Re: S/D 88-84 - *Expressway Center Addition*

STAFF REPORT
(Revised Preliminary Plat)

CASE NUMBER: S/D 88-84 - EXPRESSWAY CENTER

STAFF REPORT
(Final Plat; Revised Preliminary Plat approved 10/20/88)

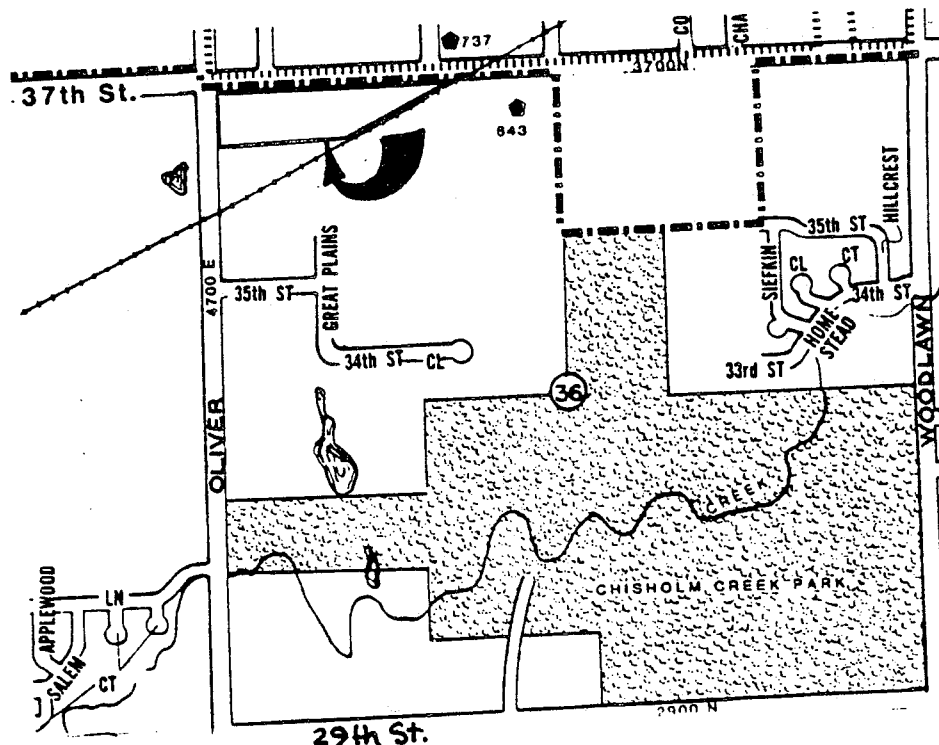
- A. The applicant shall guarantee the extension of City Water to serve the lots being platted.
- B. The applicant shall guarantee the extension of sanitary sewer to serve the lots being platted.

- C. The applicant shall guarantee any drainage improvements required by the platting of this property.
- D. The applicant shall guarantee construction of the storm sewers required by this plat.

- E. As indicated in the C.U.P., the applicant shall guarantee a continuous eastbound accel/decel lane for 37th Street North adjacent to Lots 2, 3, 4, and the west 391 feet of Lot 5. A guarantee for a temporary lane in this location shall also be provided which will be activated if the commercial center is developed prior to improvements on 37th Street North.

- G. The proposed joint access easement will need to be established by separate instrument with appropriate recording information indicated on the final plat tracing. Prior to recording the joint access easement, a draft shall be submitted to the Planning Department for review and approval. The instrument must clearly state the purpose of the easement, as well as which properties benefit from the easement. Initial construction responsibilities and future maintenance of the driveway within the easement should also be addressed by the text of the instrument.

- H. The applicant is advised that provision #7 of the associated Community Unit Plan requires the designation of a 24-foot-wide hard surfaced fire lane around main structures constructed within Lots 2, 3 and 4. This fire lane will be designated on the parking plan to be reviewed and approved at the time of building permit review.

- I. The platting of the minimum building pad elevation shall be noted on the face of the plat as well as in the platting's text.
- J. As this property is establishing minimum building pad elevations, the face of the plat shall reference the location and elevation of permanent on-site and off-site benchmarks. Section 5-402(N).

- K. Since this plat involves the platting of a floodway, the platting's text on the final plat shall reference the standard floodway language.
- L. On the final plat, complete access control shall be shown across the north and west lines of Lot 1, in the areas corresponding to the floodway. For the area outside of the floodway on the north line of Lot 1, if an access opening is desired, it shall be more clearly indicated here.

- M. The applicant is advised that Lot 1 of this plat will be limited to two buildings as is allowed under the corresponding parcel 2 of DP-101. Parcel 1 of the C.U.P. is being platting as a floodway and its development as indicated in the C.U.P. is no longer applicable to this plat. If additional building is desired for Lot 1, C.U.P., DP-161 will need to be amended.

- N. Since the C.U.P. for this site also requires building setbacks adjacent to interior lot lines (not just adjacent to the perimeter streets), the final plat shall have a note on the face of the plat that indicates: "Note: Additional building setbacks have been established under the Expressway Center C.U.P., DP-161."

- O. Prior to or at the time of submitting the final plat, the applicant shall submit a drainage plan to City Engineering for review and approval.
- P. The applicant shall install or guarantee the installation of all utilities and facilities which are applicable and described in Article 8 of the MAPC Subdivision Regulations.

Can not use Bell Aire
SS line!

STAFF REPORT
(Preliminary Plat)

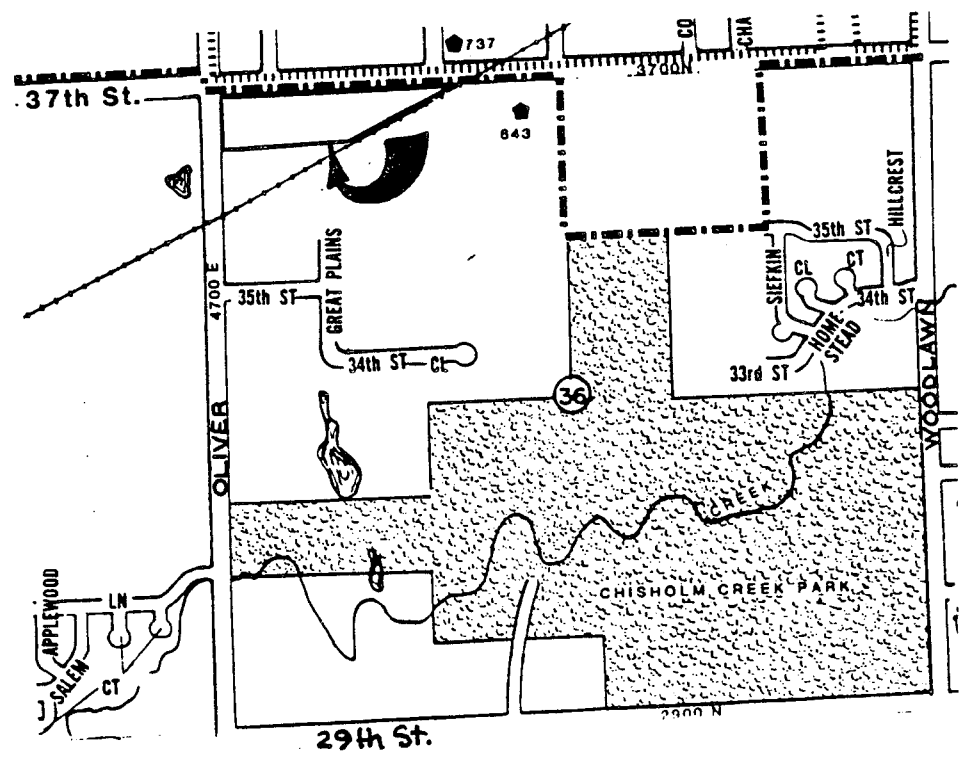
- A. The applicant shall guarantee the extension of City Water to serve the lots being platted.
 - B. The applicant shall guarantee the extension of sanitary sewer to serve the lots being platted.

- D. The applicant shall guarantee construction of the storm sewers required by this plat.
 - E. As indicated in the C.U.P., the applicant shall guarantee a continuous eastbound accel/decel lane for 37th Street North adjacent to Lots 2, 3, 4, and the west 391 feet of Lot 5. A guarantee for a temporary lane in this location shall also be provided which will be activated if the commercial center is developed prior to improvements on 37th Street North.

- G. The proposed joint access easement will need to be established by separate instrument with appropriate recording information indicated on the final plat tracing. Prior to recording the joint access easement, a draft shall be submitted to the Planning Department for review and approval. The instrument must clearly state the purpose of the easement, as well as which properties benefit from the easement. Initial construction responsibilities and future maintenance of the driveway within the easement should also be addressed by the text of the instrument.

- H. The applicant is advised that provision #7 of the associated Community Unit Plan requires the designation of a 24-foot-wide hard surfaced fire lane around main structures constructed within Lots 2, 3 and 4. This fire lane will be designated on the parking plan to be reviewed and approved at the time of building permit review.

- I. Prior to or at the time of submitting the final plat, the applicant shall submit a drainage plan to City Engineering for review and approval.

- J. The applicant shall install or guarantee the installation of all utilities and facilities which are applicable and described in Article 8 of the MAPC Subdivision Regulations.
- K. Requirements for a final plat (see pp. 20-25, Part 4, Article 5 of the MAPC Subdivision Regulations).
- L. The representative from City Engineering should be prepared to comment on the status of the applicant's drainage concept.

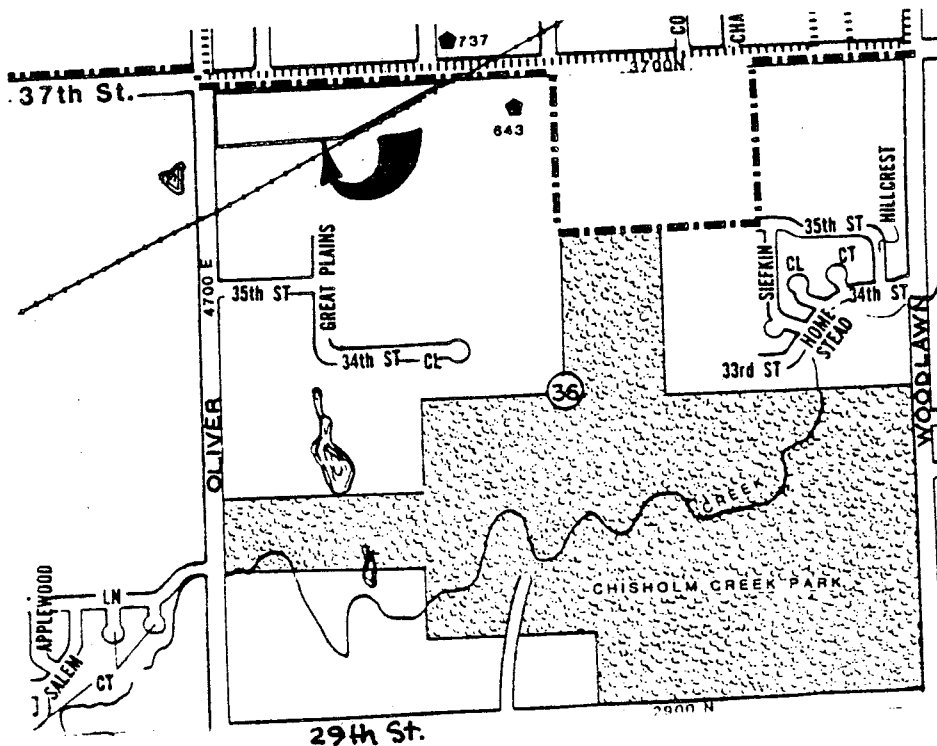
NOTE: Light Commercial ("LC") zoning has been approved for the entirety of this site, subject to the plat being recorded by October 28, 1988. The applicant has requested a six month extension of this requirement at the October 25, 1988 City Council Meeting. This plat is also subject to conditions established by the Expressway Center Commercial Community Unit Plan, DP-161.

- C. The applicant shall guarantee any drainage improvements required by the platting of this property.
- D. The applicant shall guarantee construction of the storm sewers required by this plat.

- E. As indicated in the C.U.P., the applicant shall guarantee a continuous eastbound accel/decel lane for 37th Street North adjacent to Lots 1, 2, 3, and the west 391 feet of Lot 4. A guarantee for a temporary lane in this location shall also be provided which will be activated if the commercial center is developed prior to improvements on 37th Street North.

- G. The proposed joint access easement will need to be established by separate instrument with appropriate recording information indicated on the final plat tracing. Prior to recording the joint access easement, a draft shall be submitted to the Planning Department for review and approval. The instrument must clearly state the purpose of the easement, as well as which properties benefit from the easement. Initial construction responsibilities and future maintenance of the driveway within the easement should also be addressed by the text of the instrument.

- H. The applicant is advised that provision #7 of the associated Community Unit Plan requires the designation of a 24-foot-wide hard surfaced fire lane around main structures constructed within Lots 1, 2 and 3. This fire lane will be designated on the parking plan to be reviewed and approved at the time of building permit review.

- I. The applicant is advised that Lot 1 of this plat will be limited to two buildings as is allowed under the corresponding parcel 2 of DP-101. Parcel 1 of of the C.U.P. is being platted as a floodway and its development as indicated in the C.U.P. is no longer applicable to this plat. If additional building is desired for Lot 1, C.U.P., DP-161 will need to be amended.

- J. The final plat tracing shall indicate the "film" and "page" of the joint access easement between Lots 2 and 3.
- K. There are two apparent spelling errors within the floodway text. The text indicates, "ON CR WITHIN" and "CREAIION." The spelling should read "ON OR WITHIN" and "CREATION."

- M. Perimeter closure computations shall be submitted with the final plat tracing. Section 5-101(c).
- N. Recording of the plat within 30 days after approval by the City Council.

- O. The representative from City Engineering should be prepared to comment on the status of the applicant's drainage plan. Specifically, is the minimum building pad correct? Are the boundaries of the floodway adequate; and are any drainage guarantees required with the platting of this property?
